CITY OF WEST LAKE HILLS, TEXAS
NOTICE OF BOARD OF ADJUSTMENT (BOA) REGULAR MEETING
Wednesday, December 8, 2021 at 7:00 PM

- a. Approval of the November 10, 2021 Regular Meeting Minutes
4. Land Use **1505 Wildcat Hollow**: Discuss and Consider Action on an Appeal of a Staff Decision for Denial of a Building Permit. (West Lake Hills Code Sec. 38.02.006). Agent Kim Power of Dick Clark and Associates for Property Owner Sergio Alvarez.

ALVAREZ ADDITION
1505 WILDCAT HOLLOW
WEST LAKE HILLS, TX 78746

PERMIT COMMENT RESPONSE

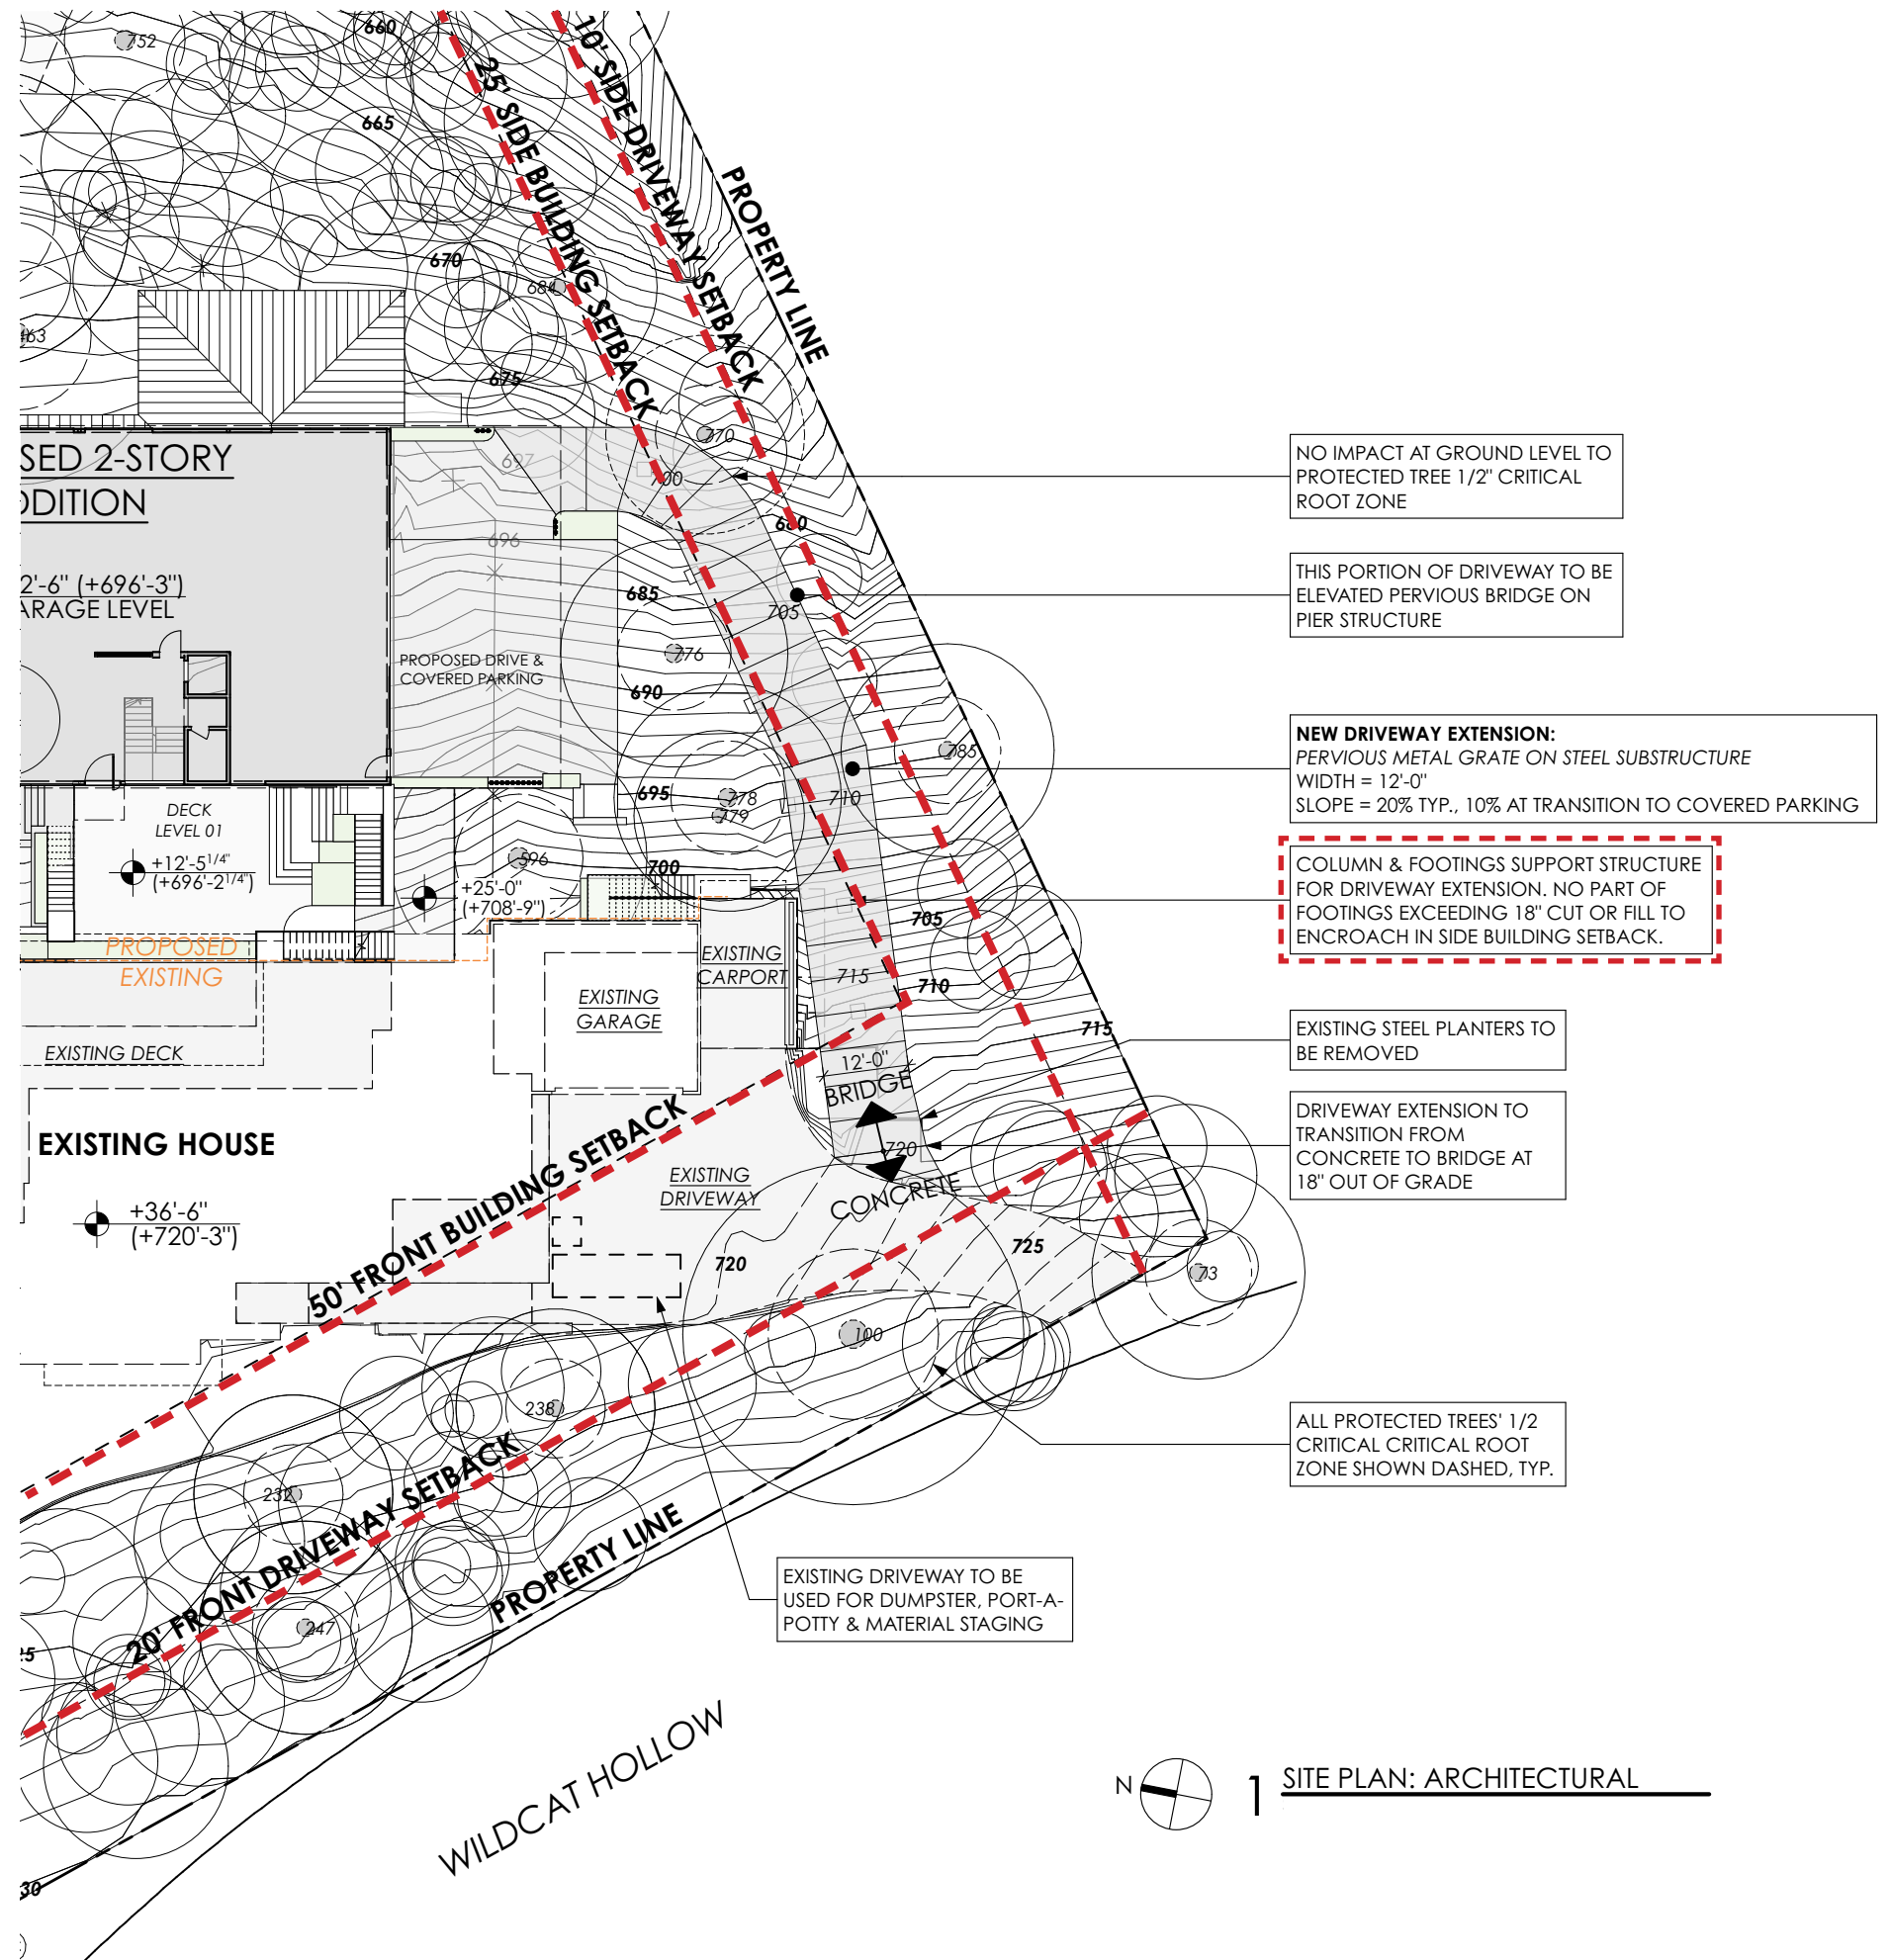
4. Driveway does not meet code Section 22.03.175. Please provide proof of code compliance. Staff has determined the driveway as proposed is a structure and would require a variance to be permitted as proposed.

- (1) *The minimum setback distance for driveways and parking areas from street right-of-way lines shall be 20 feet. Excluded from this setback is the first 20 feet of the driveway that connects to the adjacent street. Not relevant, proposed driveway extension is connecting to existing driveway behind the 20 feet driveway setback.*
- (2) *The minimum setback distance for driveways and parking areas from boundary lines shall be 10 feet. Excluded from this setback is the first 10 feet of the driveway that connects to the adjacent street. Proposed driveway extension is outside of minimum driveway setback of 10 feet. (Ref. A0.2)*

(b) Driveway entrances shall be set back at least 35 feet from the point of tangency of the curb at any intersecting street. Not relevant, proposed driveway extension is connecting to existing driveway.

(c) Adequate culverts shall be provided per the drainage and erosion control design manual. Proposed driveway extension is elevated with minimal impact to existing drainage and erosion control design. Reference Drainage Plan C5 in Drainage Plan submittal.

BASEMENT LEVEL PLAN

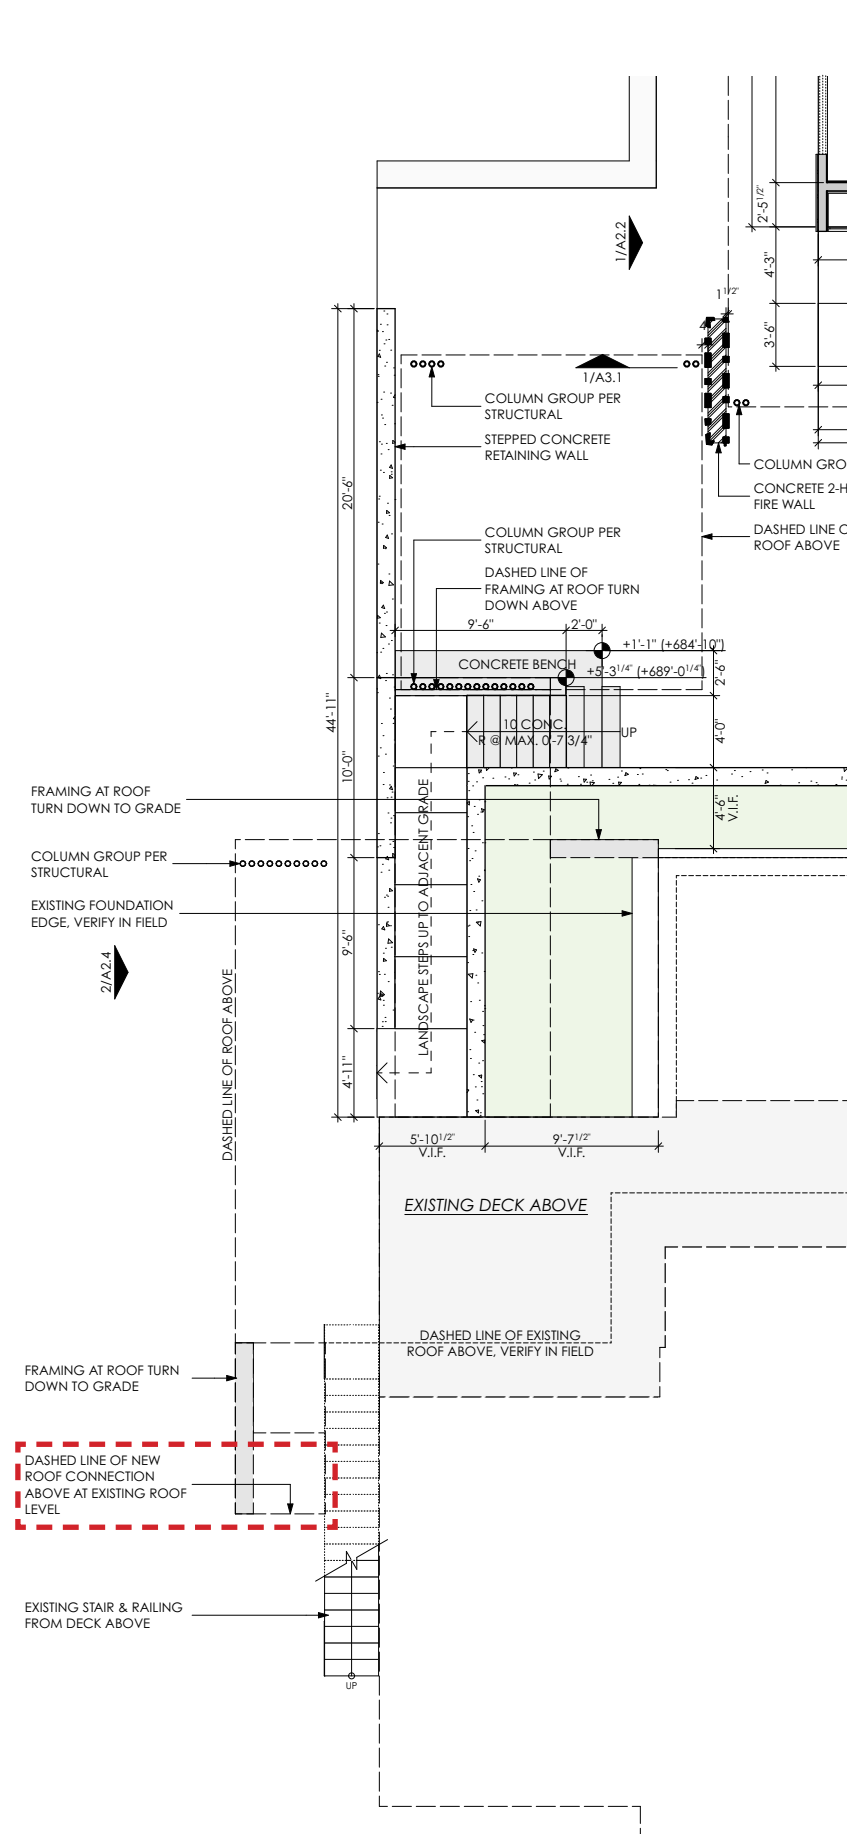
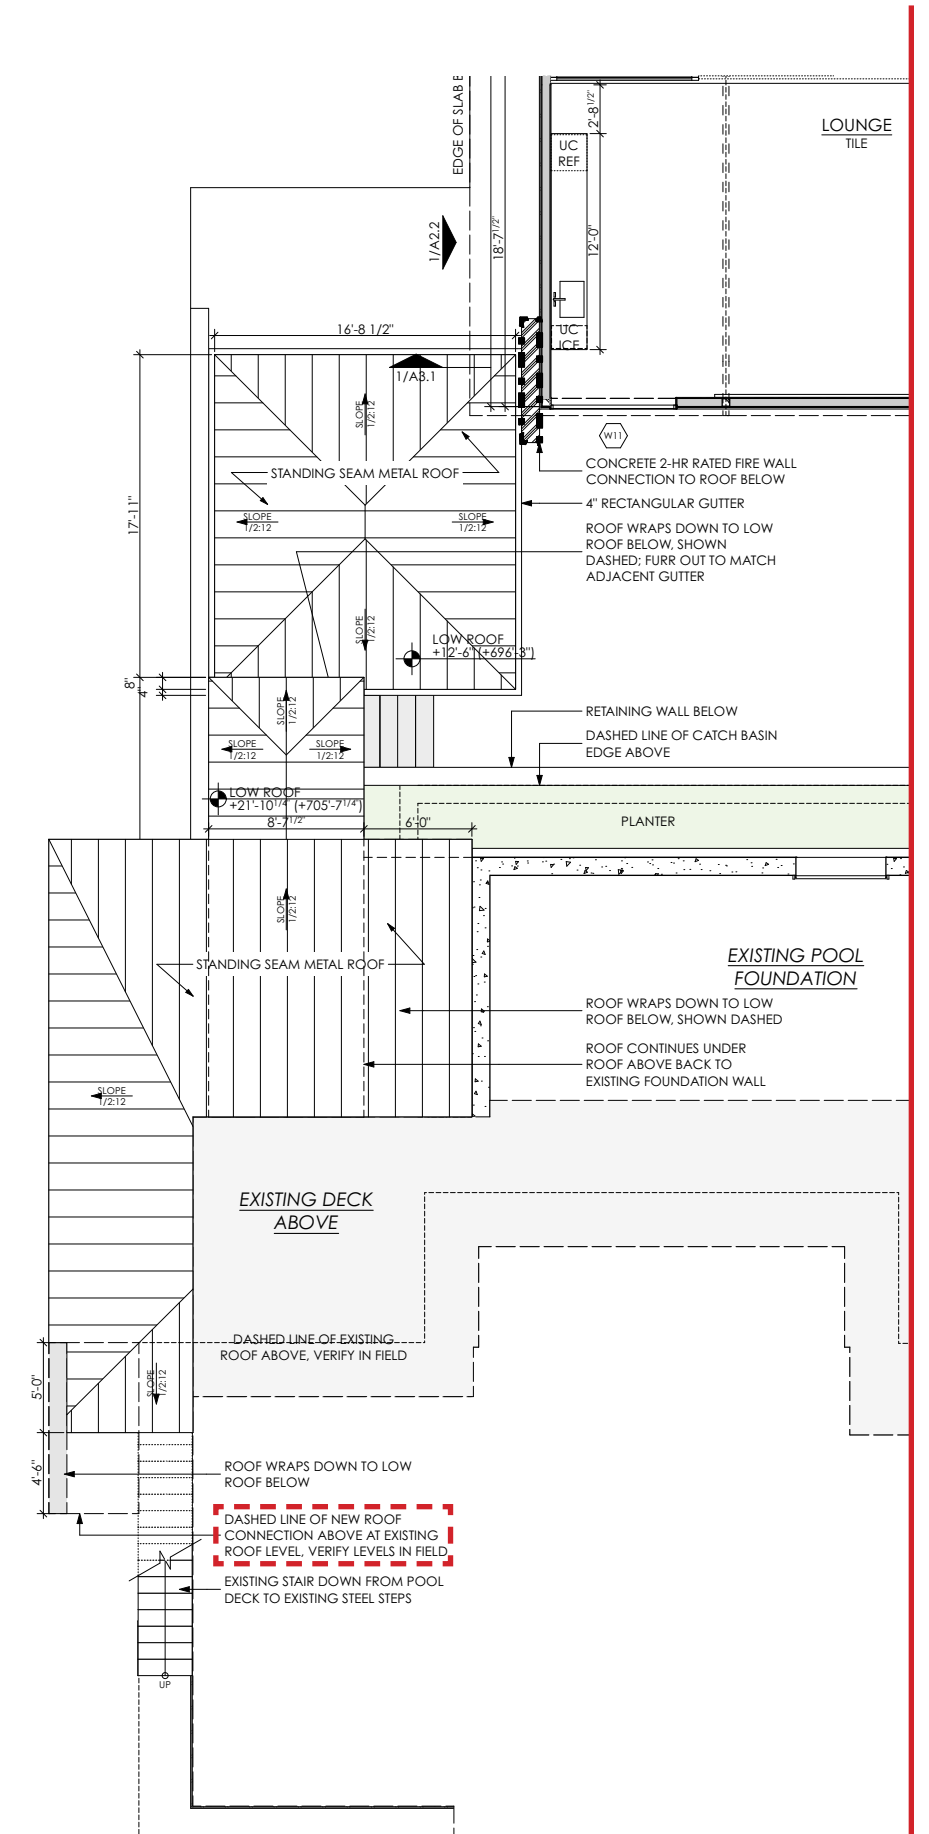
5. Addition does not meet the requirements for accessory structure, a variance is required per Section 38.03.032 and 1.01.003. Please provide proof of code compliance.

01. Proposed addition is not an accessory structure under Sec. 38.03.032 nor 1.01.003 as **the proposed addition is an extension of the existing structure with a continuous roofed connection.** This results in a single "building" per Sec. 1.01.003 definition of "building" as follows: "Any structure, either temporary or permanent, having a roof or other covering, and designed or used for the shelter or enclosure of any person, animal or property of any kind, including tents, awnings or vehicles situated on private property and used for purposes of a building."

02. Per Sec. 1.01.003 definition of "accessory structure", the use of the additional spaces conforms to the definition of "integral to, or customarily incidental and subordinate to the...principal building/structure", as it is additional bedrooms, living spaces, and garage space for the existing home. Nor is the added structure a "guesthouse" by its definition as it will be occupied continuously by a single "family".
